MIL "ON" DTC P0A80 or P0A7F due to Dust or Debris in HV Battery Cooling Fan

YEAR(S)	MODEL(S)	ADDITIONAL INFORMATION
2012	Camry HV

Some 2012 model year Camry HV vehicles may exhibit a MIL "ON" condition with Diagnostic Trouble Code (DTC) P0A80 or P0A7F stored due to dust or debris build-up in the HV Battery Cooling Fan. Use the following repair procedure to address this condition.

Figure 1.

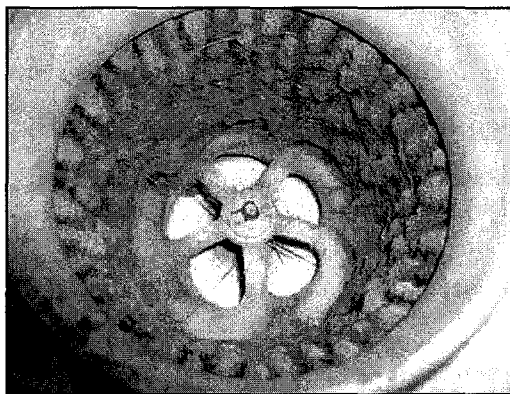
Is the HV Battery Cooling Fan clogged with dust or debris build-up? Refer to Figure 1 for an example of a clogged cooling fan.

2. Clean dust and debris build-up from the HV Battery Cooling Fan with compressed air or vacuum.

Figure 2.

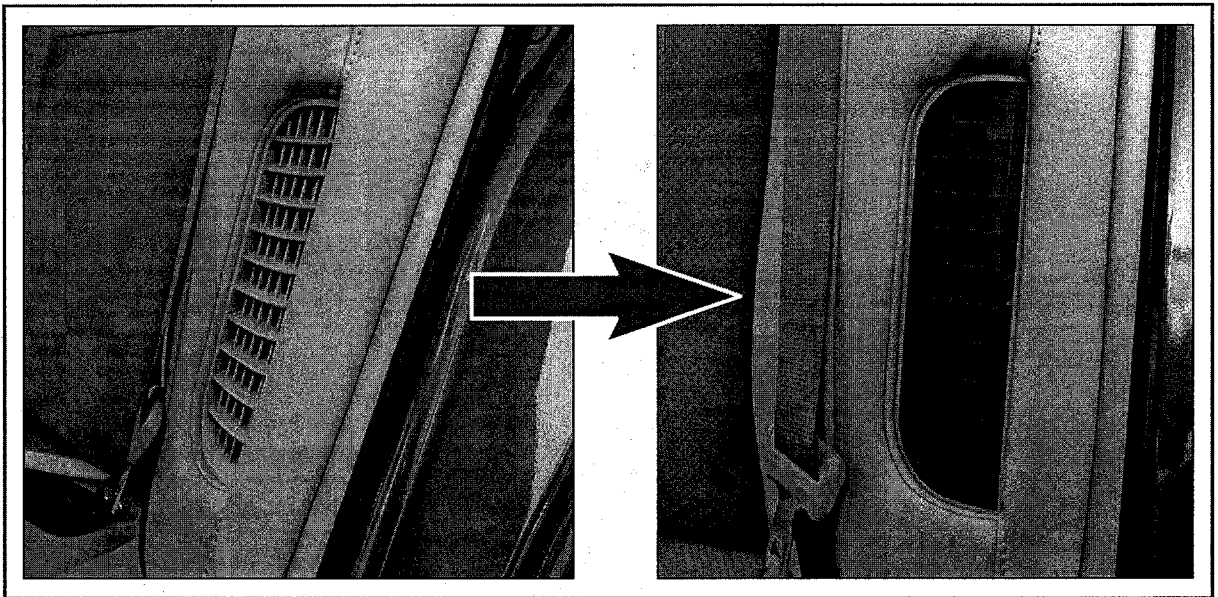
4. Install the HV Battery Cooling Fan Intake Filter as shown.

The filter should be cleaned when dust begins to appear on the surface.

Figure 3. Location of Authorized Modifications Label on 2012 Camry HV

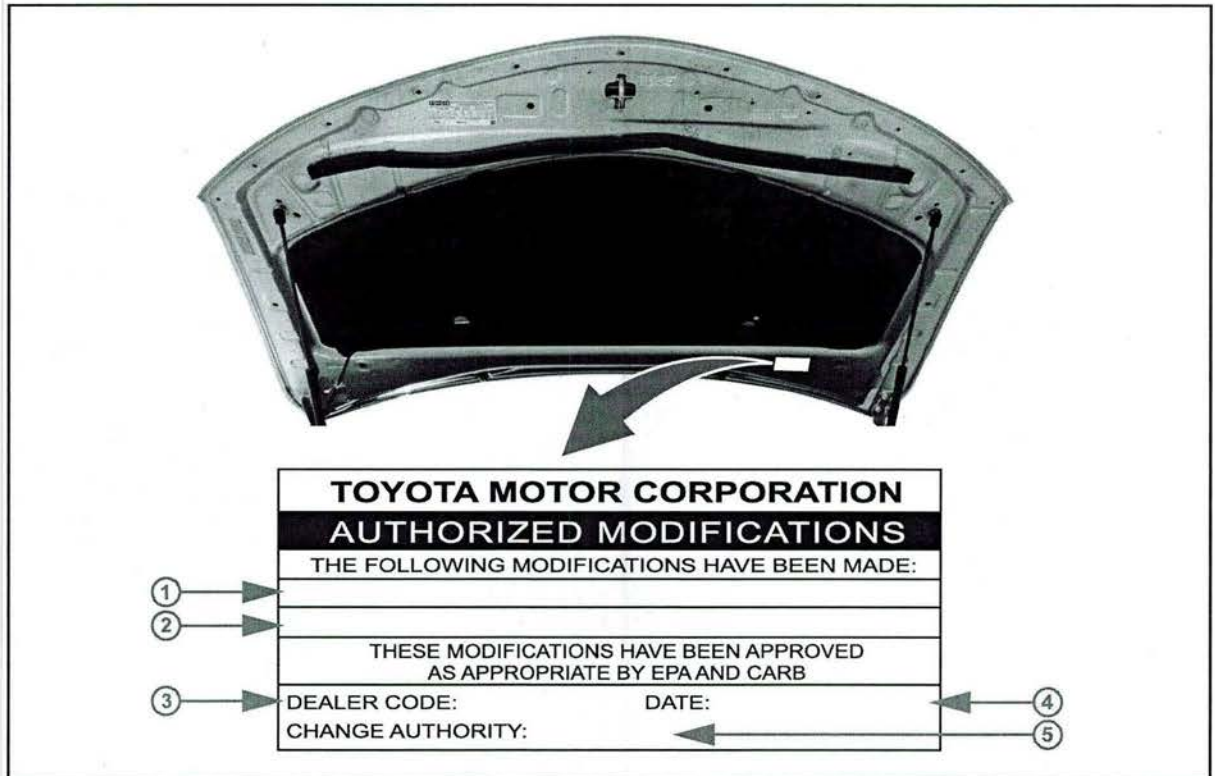
5. Check for the Authorized Modifications Label affixed to the vehicle in the location shown in Figure 3. Confirm if the Power Management ECU calibration has been updated. If the calibration ID listed is NOT the latest Power Management ECU calibration — go to step 6.
